2021 PSE Integrated Resource Plan

Appendices A-M

January 2021

DRAFT

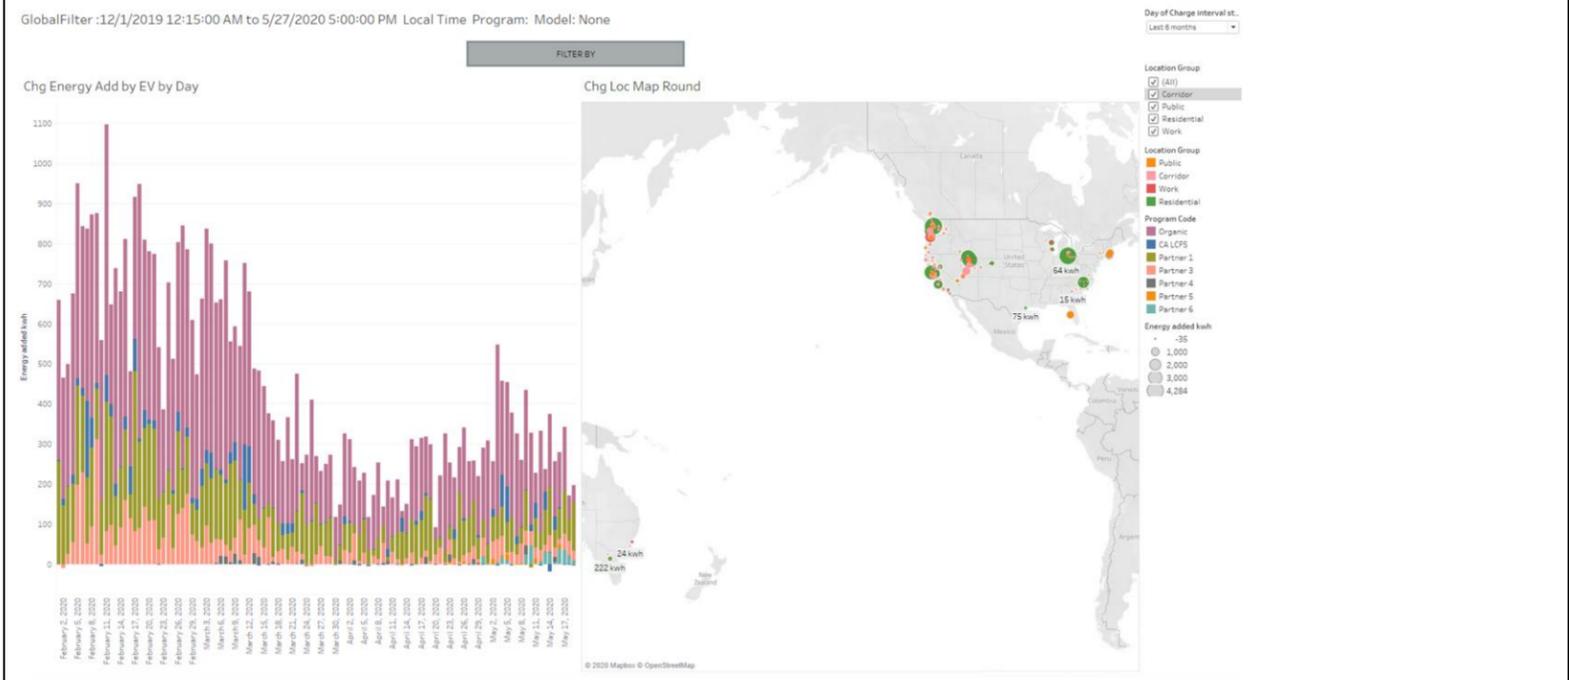
5/21/20	James Adcock	<p>This question relates to the May 28 2020 IRP Presentation, Page 25 -- -- "Operating characteristics" of Wind Resources. The source of this information is given as "NREL Database." Can you please give us a pointer to the exact "NREL Database" and information therein being used? IE a web address, etc.?</p> <p>As you know, in recent years the Wind Industry has advanced their technology, both in designing new windfoils with greater availability at lower wind speeds, which might benefit "Washington Wind Annual Average Capacity Factor" and also in improving power conversion, such that high wind generation limits have been lifted, so that more power can be generated in high-wind conditions.</p> <p>I want to make sure that your data source "NREL Database" is recent enough to capture these new Wind technological developments.</p> <p>Please answer the question asked so that we can determine whether or not your modeling assumptions include recent Wind Industry innovations that may affect resource costs, and relative resource costs, including affecting whether Wind resources are better built in Washington vs. Other States.</p>	<p>The NREL database refers to the 5-min wind speed data obtained from NREL's Wind Toolkit database: https://www.nrel.gov/grid/wind-toolkit.html. The NREL Wind Toolkit data contains mesoscale modeled data from 2007 to 2013. Only wind speed data was used from the NREL database, capacity factors were calculated by PSE analysts with experience in wind energy assessment in order to employ up-to-date wind technology and methods.</p> <p>The raw, 100m above ground level wind speed data was processed using industry-informed methods to calculate hourly net production shapes. Processing steps include:</p> <ul style="list-style-type: none"> • Re-average 5-min wind speed data to hourly wind speed data • Calculate gross production using the air density adjusted, power curve for a GE3.03-140 as a model turbine • Apply loss factors including estimated wake impacts, stochastic availability losses, turbine performance losses, environmental losses (stochastic icing shutdown, high/low temperature shutdown) and electrical line losses to calculate a final net production shape. • Validate net production calculation against existing NREL Wind Tool Kit net capacity factor estimates and DNV GL production calculations for select sites.

<p>This process was repeated for 250 unique locations surrounding the point of interest, then the most representative shape was selected for the deterministic Portfolio model.</p> <p>The described process has only been performed for the wind resources added to the 2021 IRP (Wyoming and Idaho wind resources). 2019 IRP wind resource characteristics (Washington, Montana, Offshore) were obtained from HDR and DNV GL 3rd party analysis. The HDR report is available for review on the PSE IRP website (pse.com/irp). Documentation for the DNV GL wind shapes is not available at this time.</p>
5/28/20	Brian Grunkemeyer, FlexCharging	<p>When evaluating resources, do you apply a discount rate to the value of energy produced?</p> <p>This article below in Utility Dive makes an argument that the Levelized Cost of Energy hurts renewables because the math is wrong. The author observes that LCOE doesn't apply a discount rate to the value of energy produced in the out years. The claim is LCOE overprices wind & solar by 18% and 27% respectively compared to natural gas. The author is pushing a slightly corrected metric, the "present value of the cost of energy" instead of LCOE.</p> <p>https://www.utilitydive.com/news/lcoe-is-not-the-metric-you-think-it-is/578360/</p> <p>It's possible PSE doesn't use LCOE at all in its resource evaluation. But it may be useful to understand whether discount rates apply to the value of energy produced as well as operating costs. This same thought process could apply to conservation as well, correct?</p> <p>Please inform the IRPAG about whether it is reasonable to apply a discount rate to the value of energy when valuing resources & conservation measures, and whether you do so.</p>	<p>Resources are evaluating on an annual basis for the life of the plant, we do not use the levelized cost of energy in the models.</p> <p>The discount rate is only applied at the end to levelize the costs for charts and tables that are used for comparison.</p>

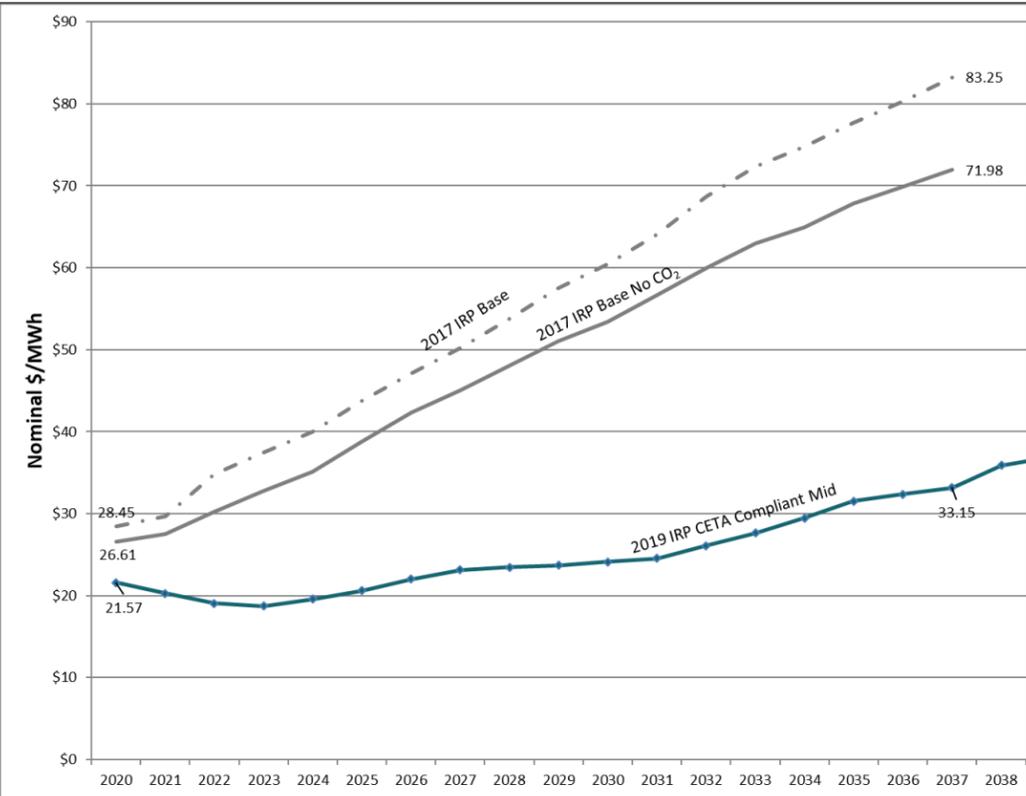
6/4/2020	James Adcock (14)	Do not reference the "2019 IRP" because there is no "2019 IRP" -- because PSE chose unilaterally with consulting stakeholders to terminate the 2019 IRP Process before it was completed.	Please see our response to your comments 5,10 & 13.
6/10/2020	Vlad Gutman-Britten, Climate Solutions	<p>Slide 17: Why are no thermal plants built in WA? Is this CETA or some other constraint? It again reads like SCC is only applied to plants in Washington and not outside of it, which isn't in keeping with the requirements of CETA or the previous UTC acknowledgement letter.</p> <p>Slide 19: There are other extant policies/commitments that should be included—Xcel has committed to 100% clean by 2050, Idaho Power and Avista have both made the same commitment. A number of CO laws also matter here: Colorado utilities must consider SCC in planning and the PUC must make progress toward 90% carbon reduction by 2050. These will impact resource choices and price forecasts.</p> <p>Slide 20: For the utilities below 80%, these are likely to somewhat overcomply with the 2030 requirement in order to address variability in hydro. It could be worth modeling actual compliance strategies as this will yield a different mix of renewables and thus impact price forecasts.</p> <p>Slide 21: Assumption shouldn't be no new renewable energy investments until 2028. Considering only state-wide RE need doesn't reflect how utilities, especially investor-owned utilities, will comply.</p> <p>Slide 22: Would like to see the 2017 with high CO2 comparison since the 2019 does have CO2 included.</p> <p>Slide 29: why did price increase on this slide when on slide 27 it appears to have declined slightly?</p> <p>Slide 34: A little confused on the difference between the two scenarios with CA/WA; shouldn't frame CA 2045 law as a "goal"; CA 2030 requirement is RPS only, not carbon-free.</p> <p>Slide 42: Scenario #3 should have a higher CO2 price, going beyond what is required by law for the "high scenario." Scenario #4 appears to be a baseline comparison, and should include CETA but not the clean energy standards.</p>	<p>Slide 17: Given that PSE is modeling the entire region as a whole, the model assumes that there is plenty of resources in the region given normal hydro conditions and mid load. This is different than the PSE portfolio model, where PSE is accounting for transmission constraints into the PSE service territory. So even though there might be enough resources in the region, it may not be delivered to load due to transmission constraints. To reflect the social cost of carbon planning adder in PSE's portfolio model, market purchases will include a wheeling cost equivalent to the SCC adder during the capacity expansion run.</p> <p>Slide 19: PSE has elected not to include corporate or non-binding policies into the Power Price model due to lack of accountability of these policies and difficulty in modeling numerous policies at the balancing authority resolution.</p> <p>Slide 20: Thank you for the suggestion, however, PSE is unable to incorporate actual clean energy adoption strategies into the modeling process due to lack of insight into the resource acquisition strategies of each Washington utility. Therefore, PSE has elected to model either the 80% clean energy implementation required by CETA or a generic more aggressive (~90%) clean energy implementation for the 2021 IRP.</p> <p>Slide 21: Thank you for the suggestion, PSE is updating the assumption and will have the updated targets for the July 1 consultation update.</p> <p>Slide 22: Below is the updated chart which includes the 2017 IRP Base power price:</p>

Slide 29: Slide 27 shows the annual, nominal power price for the 2019 IRP process and draft 2021 IRP power price. Slide 29 shows the levelized power price over the timeframe for each IRP process, which incorporates the time value of money (net present value). Each slide is an NPV over different time periods which is why they are slightly different.

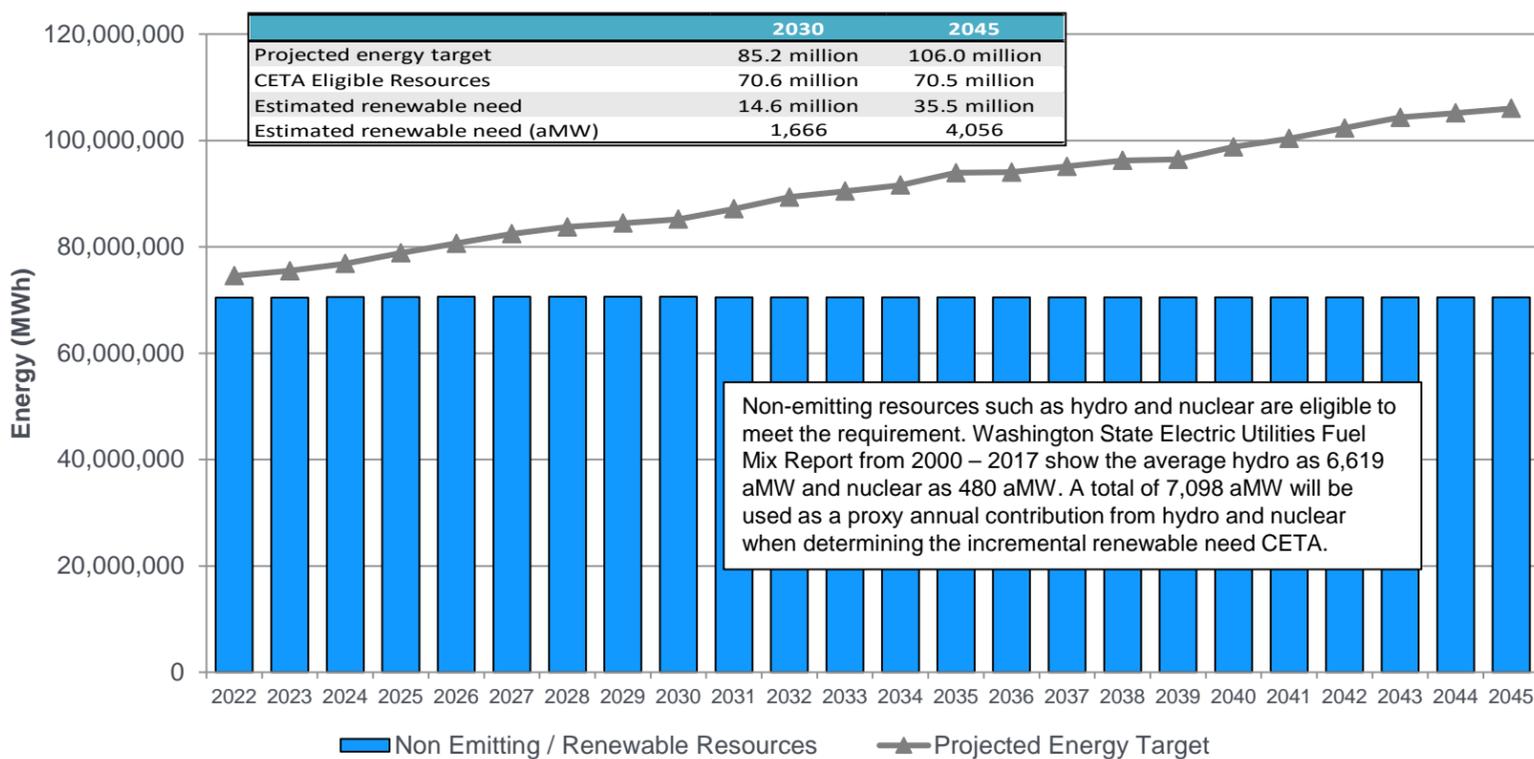
PSE received feedback from Vlad Gutman-Britten (Climate Solutions) and James Adcock regarding the starting point for the renewable ramp used for meeting the Washington state CETA requirements.

PSE response: PSE updated the Washington renewable need for the updated demand forecast and started the ramp in 2022.

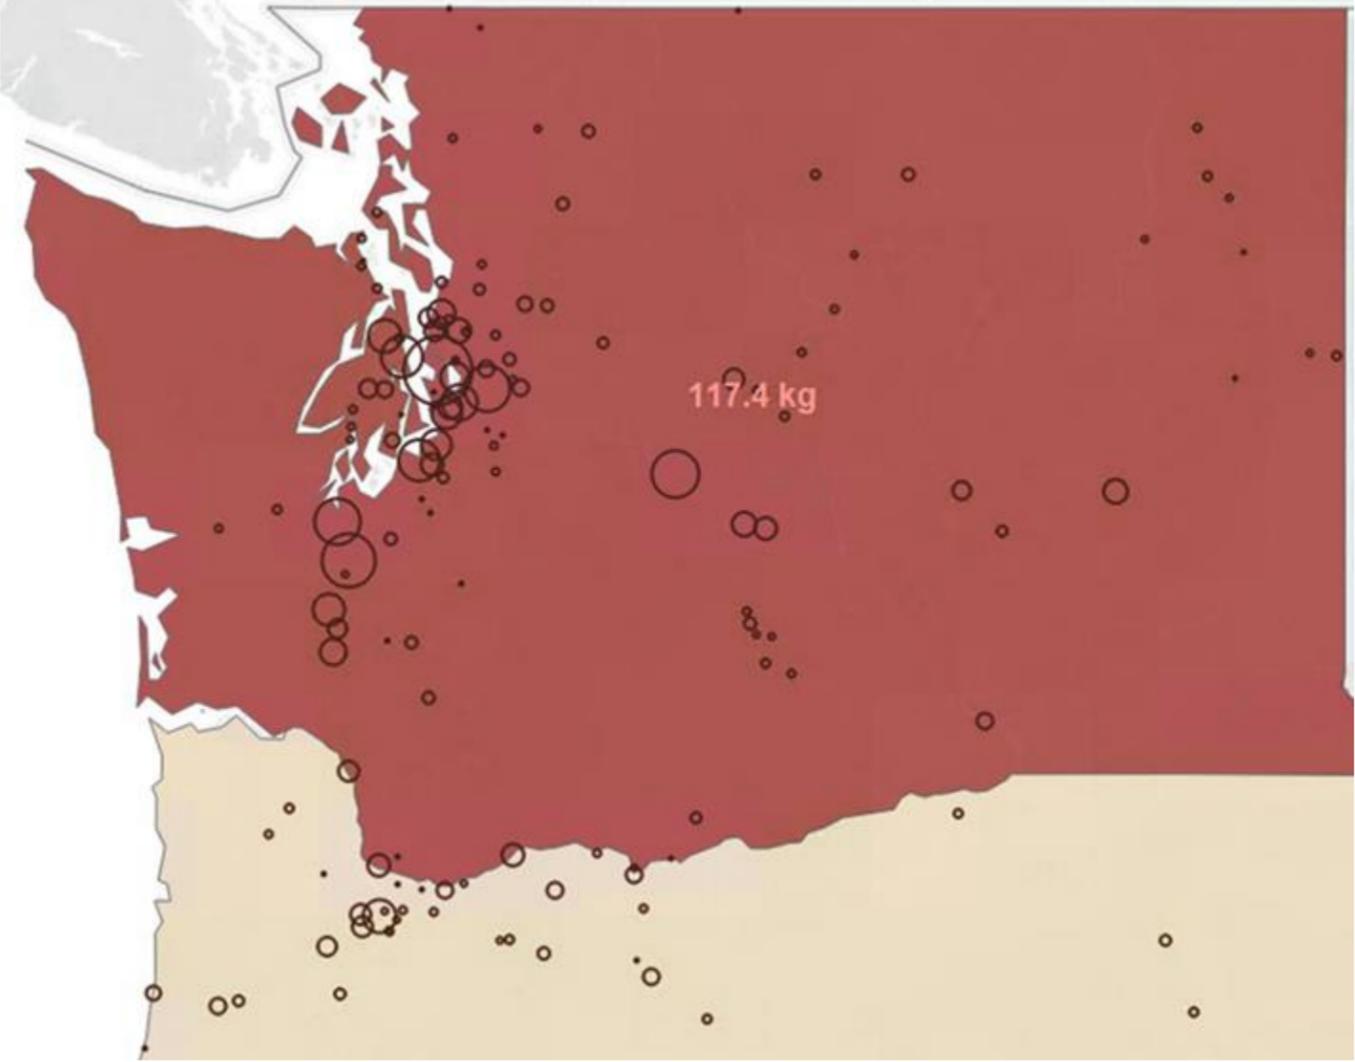
11/16/2020	Cress Wakefield, ARUP	<p>Recommend including timelines as part of the IRP on delivery system planning for DERMS and TOU, as the carbon initiatives of large commercial companies and cities seem to be outpacing the readiness of the utilities. Even if the incentives/pricing were unclear, it would help with planning.</p>	<p>Thank you for your suggestions. The timeline for TOU pilot activity will be included in the IRP. The timeline for DERMS implementation is in development, but will be discussed in the IRP.</p>
11/16/2020	Brian Grunkemeyer Founder & CEO FlexCharging, Inc.	<p>I wanted to follow up with Tyler Tobin and Ben Farrow about tailpipe emissions from gasoline cars. We can use that to justify accelerating EV adoption. We have a deep but not broad data set. I suggest we could work together to collect more data to better make a compelling case for additional spending on increasing EV adoption.</p> <p>In terms of indicators of equity, I suggest you include air pollution. Specifically, EV investments that speed up adoption will avoid tailpipe emissions from gasoline vehicles, <i>in specific communities</i>. We all know air pollution impacts human health, through asthma attacks and shortened lifespans. But programs increasing EV adoption can help avoid air pollution, and therefore avoid these health impacts and costs.</p> <p>For the vehicles signed up with FlexCharging, my team has analyzed the avoided NOx + NMOG tailpipe pollution, grouped by city. There are also avoided pollution from particulate matter, formaldehyde, and carbon monoxide, all informed by EPA estimates. Note most of the drivers live in the Seattle & Eastside area (and some in Portland), but the avoided tailpipe emissions impact is statewide. This data of course requires tracking cars & where they drive, instead of focusing on smart plugs.</p>	<p>Thank you for input and suggestions. This is interesting work, which may hold value during the development of PSE's Clean Energy Action Plan (CEAP) and Clean Energy Implementation Plan (CEIP). PSE will follow up outside of this Feedback Report to learn more about FlexCharging, Inc.'s data set and its applicability to PSE's models.</p>
